Wheel Horse Service Bulletins 1961 - 1990: **#84** Issued: February 1967

Recommended Oil and Filter Change Period - Hydro-Gear Transmissions

**Ignition Switch and Wire Kit #6083 - 1968 10 & 12 H.P. Models with
10 AMP. Alternators**

Wheel Horse Service Bulletins 1961 - 1990: **#126** Issued: November 1970
Service Replacement Electric Clutch - 1968-70 Electro and GT 14 Tractors

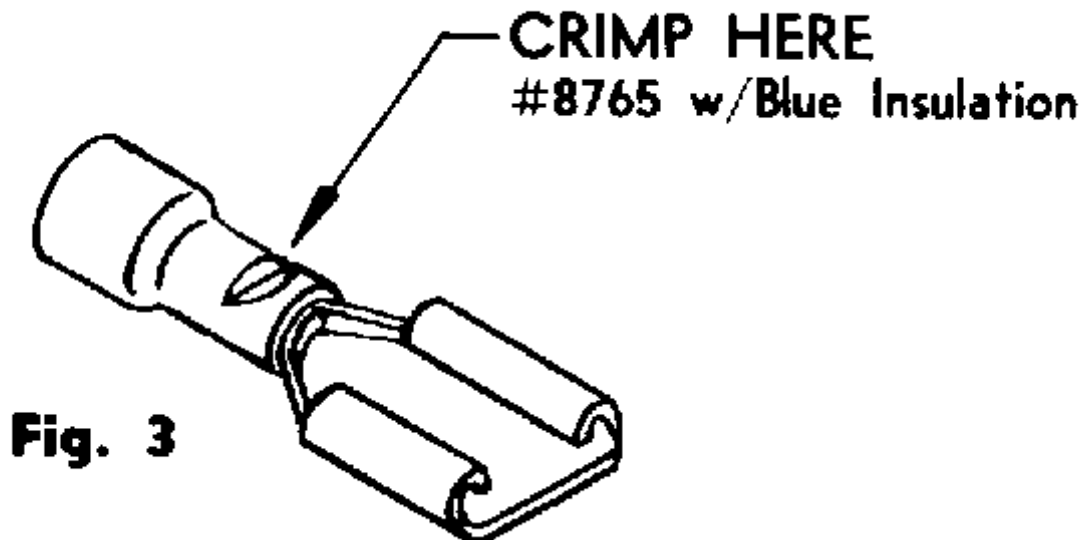
A new improved Ignition Switch, Part #8362 has been developed and is now available in a kit making it adaptable to all 1968 10 and 12 H.P. model tractors with 10 Amp. alternator.

This switch provides 4 positions as shown in Fig 1.

The key must be manually moved from the Run position to the Run and Accessories position before current is supplied to the lights, cigar lighter, or electric clutch, if so equipped. The battery is charged in both the Run and the Run and Accessory position.

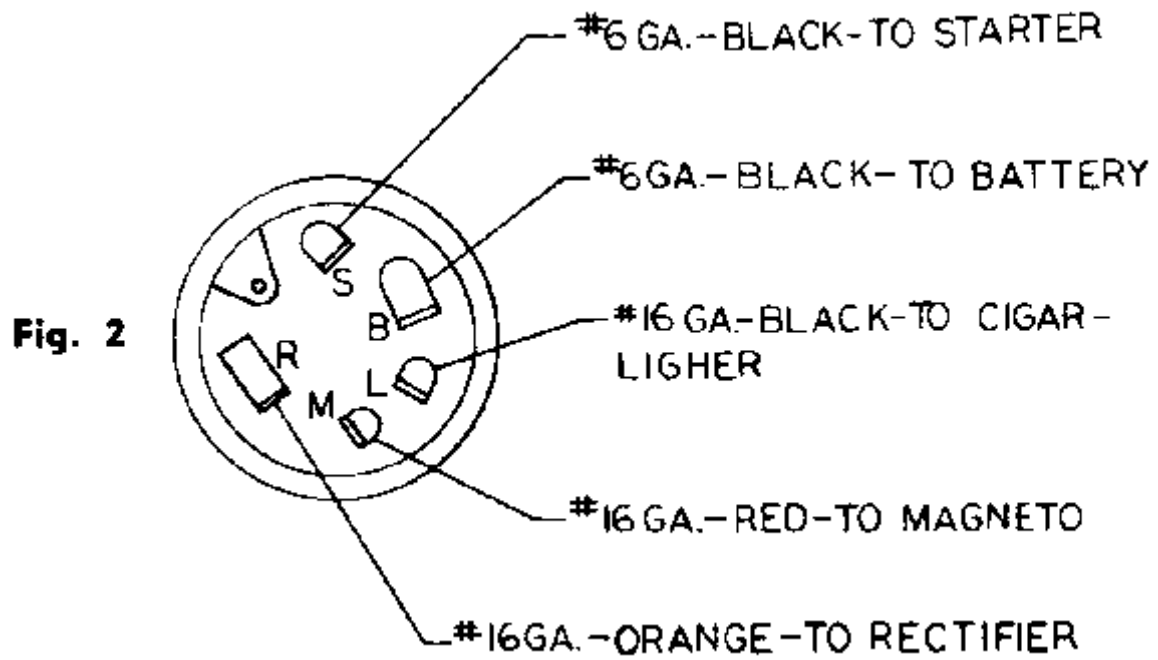
10. Install the 9/16" diameter lock washer and the plastic insulator over the threaded switch hub and position the switch in the instrument panel. Install the switch retaining nut and tighten securely while holding the switch body from turning, making sure switch key slot is vertical. NOTE: The large #6 Battery and Starter wires have a tendency to distort the switch terminals if they are misaligned. Make sure all terminals are tight and insulated from each other. Recheck wiring making sure it checks with Fig. 2.

Order Part No. 101636.

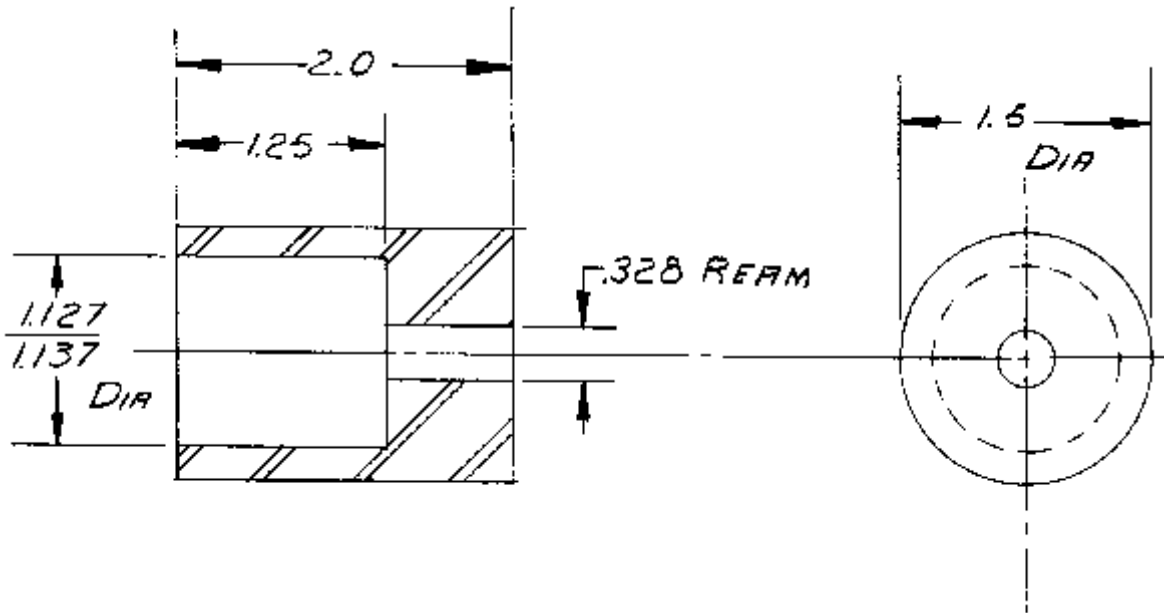
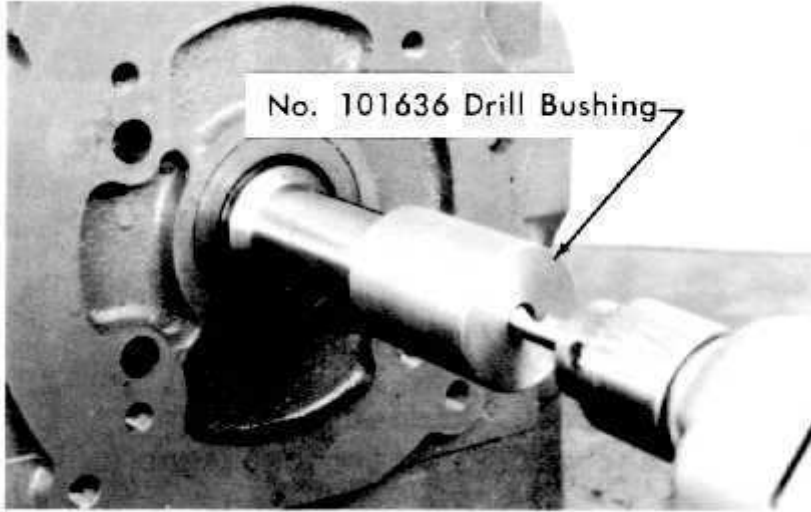
CRANKSHAFT DRILLING INSTRUCTIONS - To replace #7915 clutch with #101473

1. Remove electric clutch, engine pulley and crankshaft key.
2. Fit trill bushing on end of crankshaft and trill crankshaft to a depth of 1 3/8" with 5/16" dia. drill.
3. Tap hole 3/8-16 thread to a usable depth of 1".

The drill bushing illustrated here can be made up locally from the shop drawing reproduced below or purchased through your Wheel Horse distributor.

Figure 1

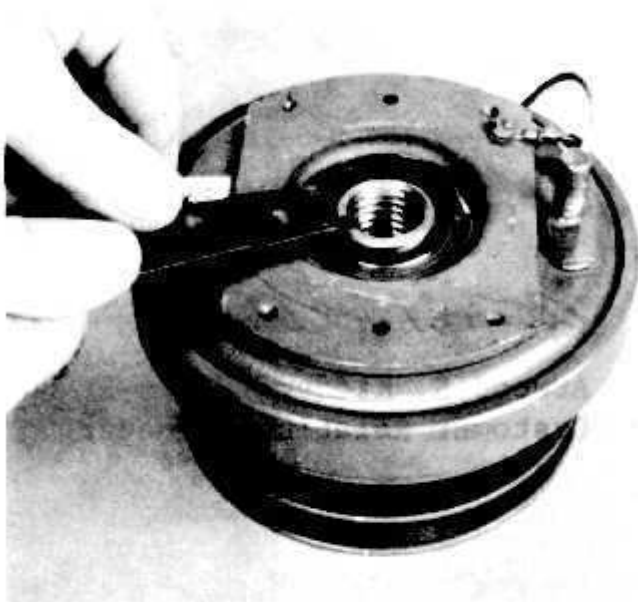
1. Remove clutch from engine crankshaft using a 1"-8 threaded bolt 5" long as a puller screw.
2. Remove the small external retaining ring as shown in figure 1 (#7915 only).

Figure 4

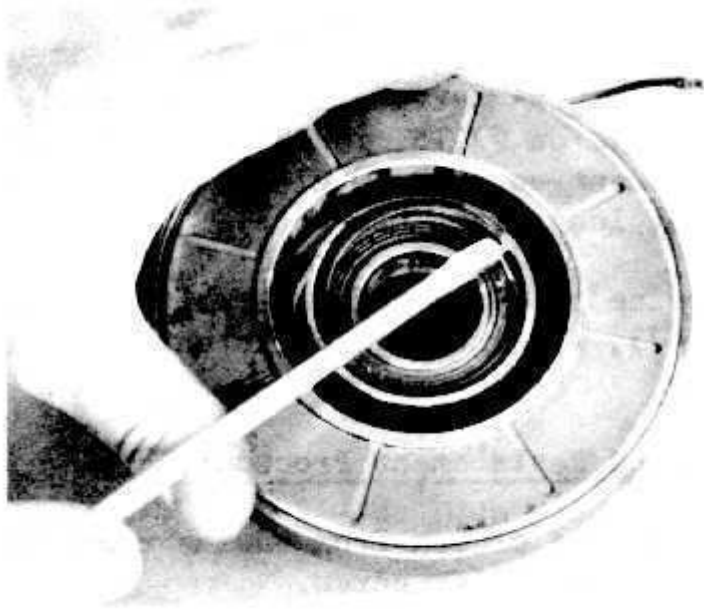
5. Remove the inside bearing snap ring (figure 4) and press the bearing out from the other side of the field assembly.

6. Press the new bearing, Part No. 101380, into place and reinstall the snap ring. Using an arbor that contacts only the inner bearing race, press the clutch halves together until the inner race stops against the hub shoulder. If #7915 reinstall the external retaining ring.

Ignition Switches - 1972 Models

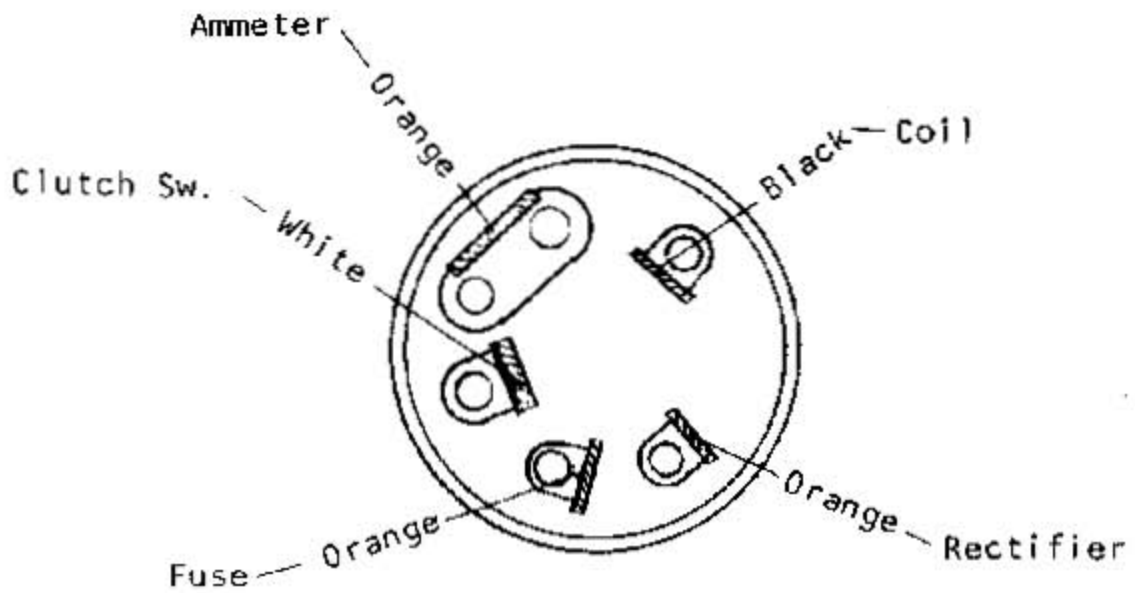
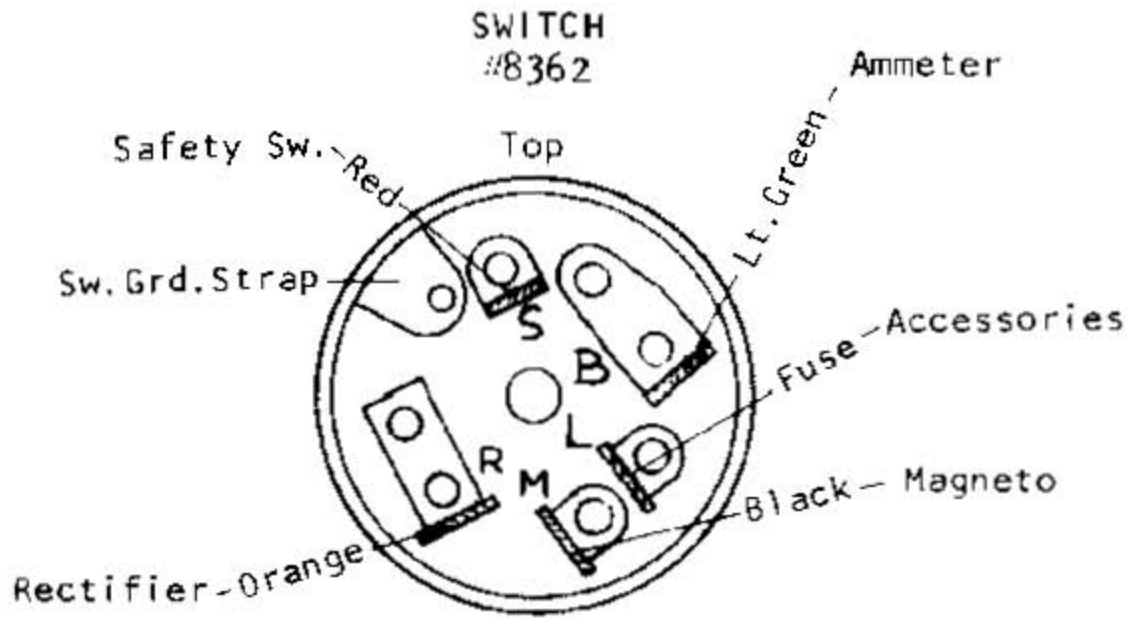
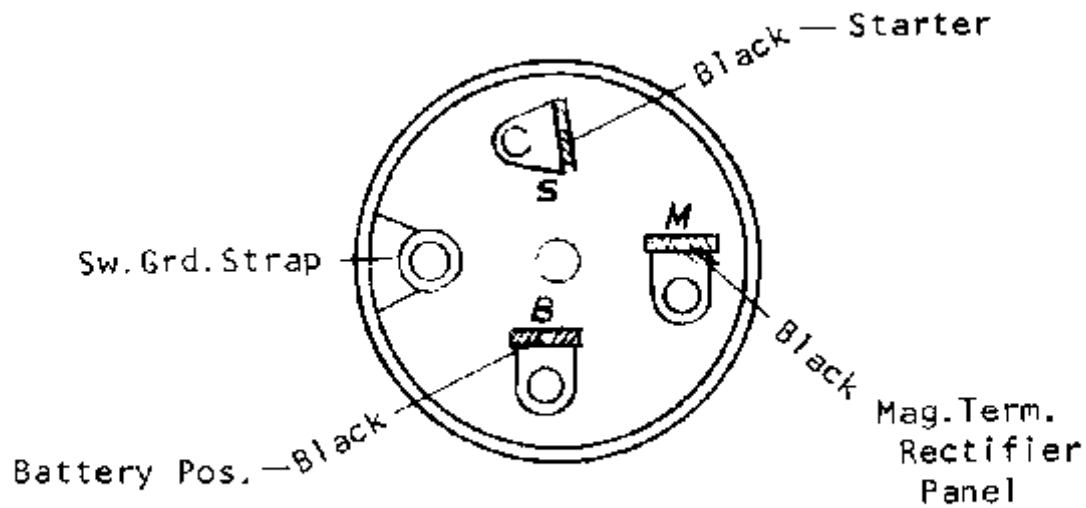
As four (4) different Ignition Switches are used on 1972 models it is extremely important that replacement switches be identified properly to avoid damage to the electrical system.

The four (4) switches are pictured below as seen from the terminal side of the switch. The terminals are identified on the pictures as some of the switch terminals are not marked correctly or are not marked at all.

FIG.1

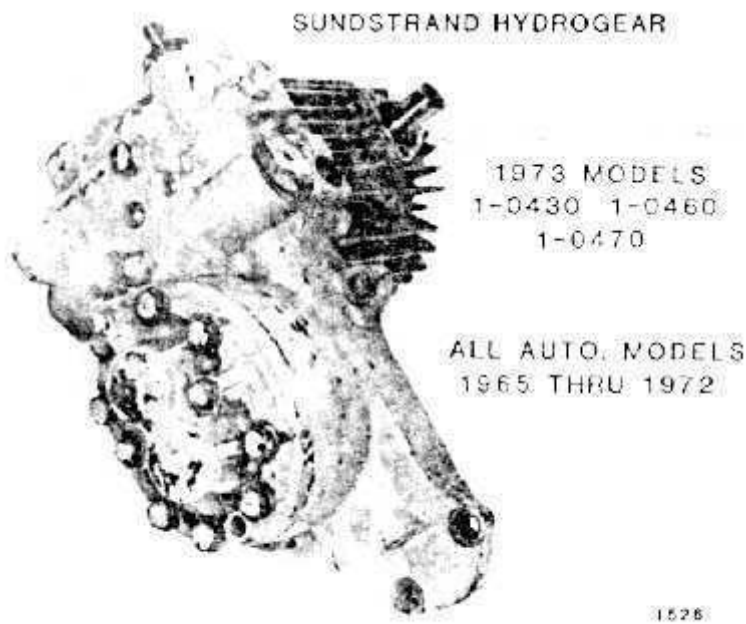
2.1 Sundstrand Hydrogear (Fig. 1)-Contact the following company for rebuilding services and repair parts needed.
